Project	IEEE 802.16 Broadband Wireless Access Working Group < http://ieee802.org/16 >	
Title	Proposal for updating 802.16 standard architecture reference model	
Date Submitted	2006-01-09	
Source(s)	Philip Barber Zou Lan Fu Yan Huawei Technologies	Mailto: zlan@huawei.com
Re:	Contribution on IEEE 802.16-2004/IEEE802.16g	
Abstract	This contribution proposed to update the system architecture reference model of 802.16-2004. And remove the corresponding description in 16g.	
Purpose	Adoption	
Notice	This document has been prepared to assist IEEE 802.16. It is offered as a basis for discussion and is not binding on the contributing individual(s) or organization(s). The material in this document is subject to change in form and content after further study. The contributor(s) reserve(s) the right to add, amend or withdraw material contained herein.	
Release	The contributor grants a free, irrevocable license to the IEEE to incorporate material contained in this contribution, and any modifications thereof, in the creation of an IEEE Standards publication; to copyright in the IEEE's name any IEEE Standards publication even though it may include portions of this contribution; and at the IEEE's s

Figure A – Network Reference Model

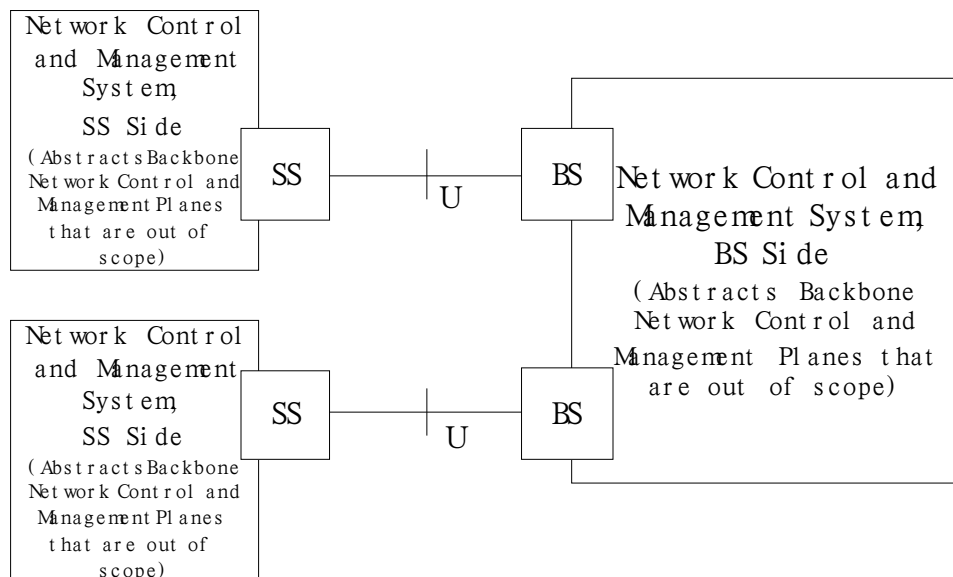
The Figure A describes a network reference model along with the interfaces that are within the scope of this specification. Multiple SS or MS maybe attached to a BS. ~~The SS communicate to the BS over the U interface using a Primary Management Connection or a Secondary Management Connection. MS typically only utilize the Primary Management Connection over the U interface for management and related control functions.~~ **SS or MS communicate to the BS over the U interface using a Primary Management Connection, a Basic Management Connection or a Secondary Management Connection.**

Figure B Illustration of BS side Network Control and Management System

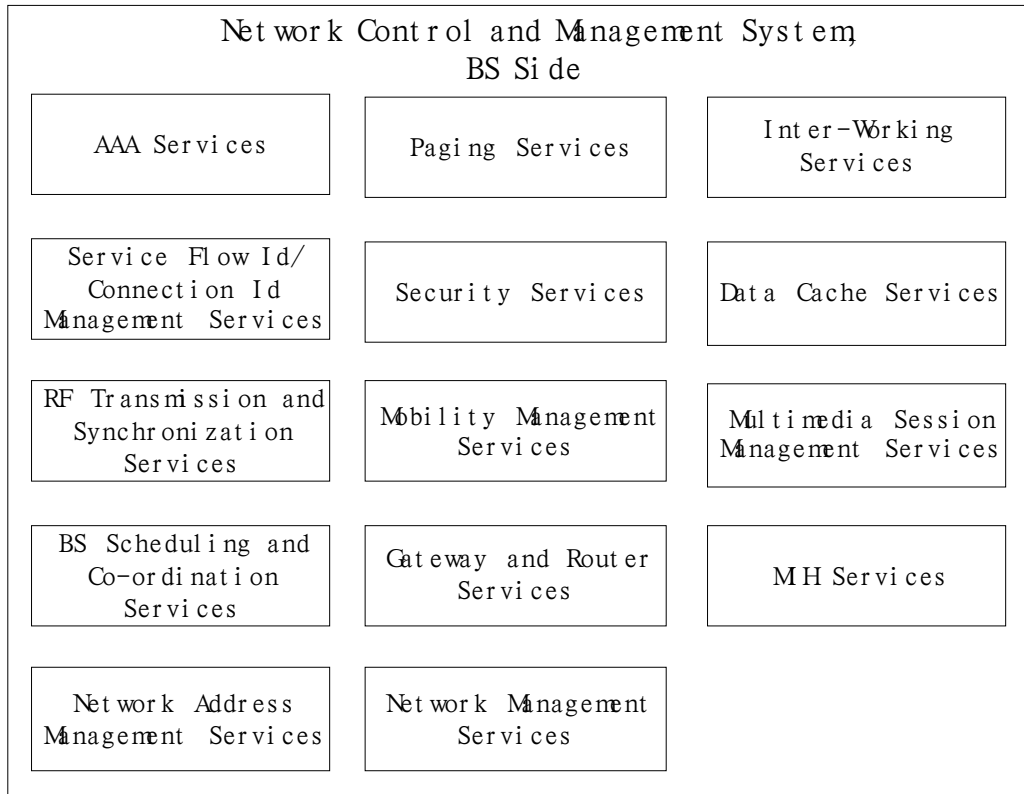
This abstraction is detailed shown the different functional entities that make up a Network Control and

Management System. For different network elements, the corresponding NCMS functions are also different. The exact functionality of these entities and their services is outside the scope of this specification but shown here for illustration purposes and to better enable the description of the management and control procedures. The illustrated BS side NCMS functions are shown in Figure B.

Figure C Illustration of SS side Network Control and Management System

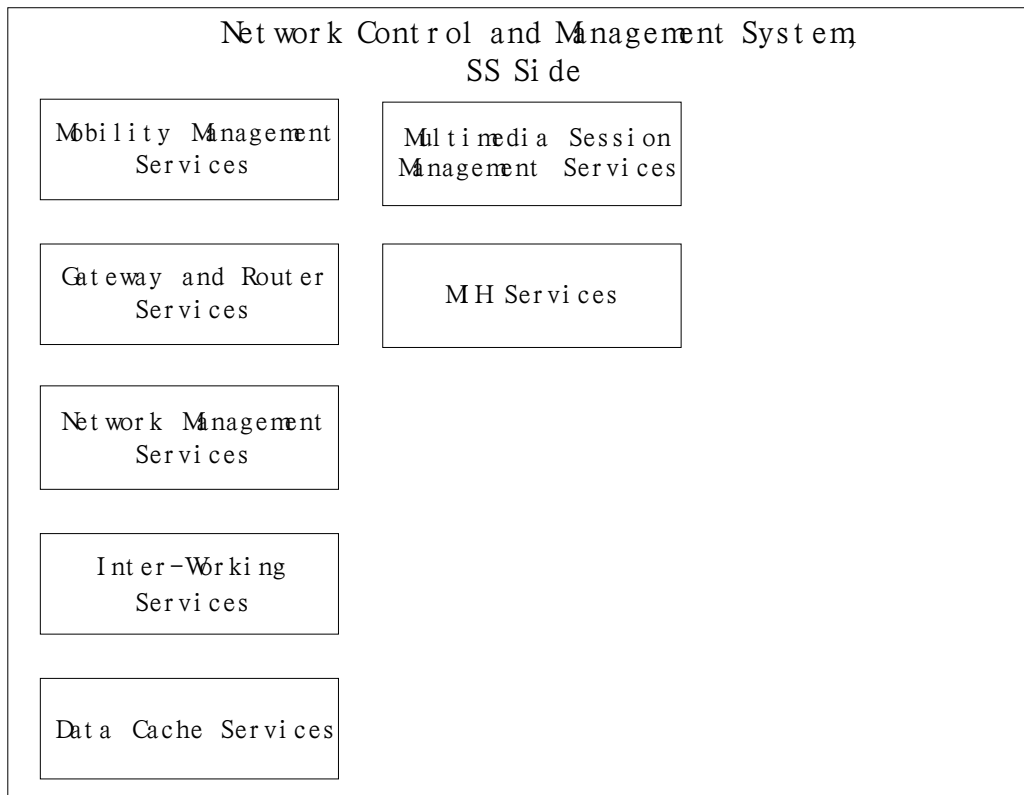
The illustrated SS side NCMS functions are shown in Figure C.

Figure D System Architecture Model

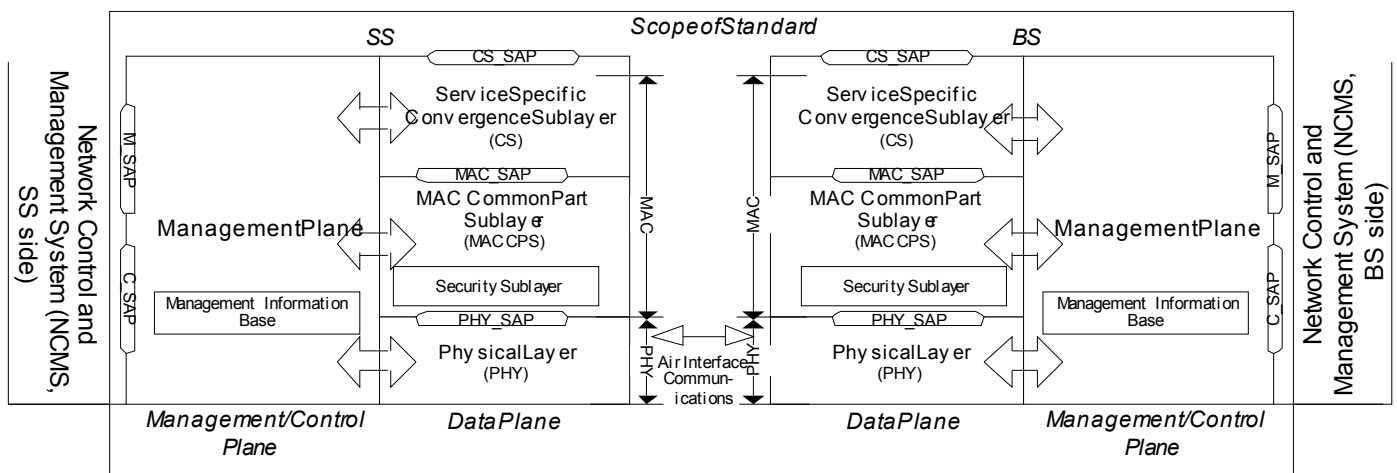
The system architecture is shown in Figure D.

This interface is a set of Service Access Points (SAP) between SS/MS and NCMS and is represented in the Figure D. It is decomposed into two parts: the Management SAP is used for Management plane primitives alone and the Control SAP is used for Control plane primitives that to support handovers, security context management, radio resource management, and low power operations (such as Idle mode and paging functions). The primary goal of such an interface is to ensure protocol separation.

This interface is a set of Service Access Points (SAP) between BS and NCMS and is represented in the Figure D. It is decomposed into two parts: the Management SAP is used for Management plane primitives alone and the Control SAP is used for Control plane primitives that to support handovers, security context management, radio resource management, and low power operations (such as Idle mode and paging functions). The primary goal of such an interface is to ensure protocol separation.
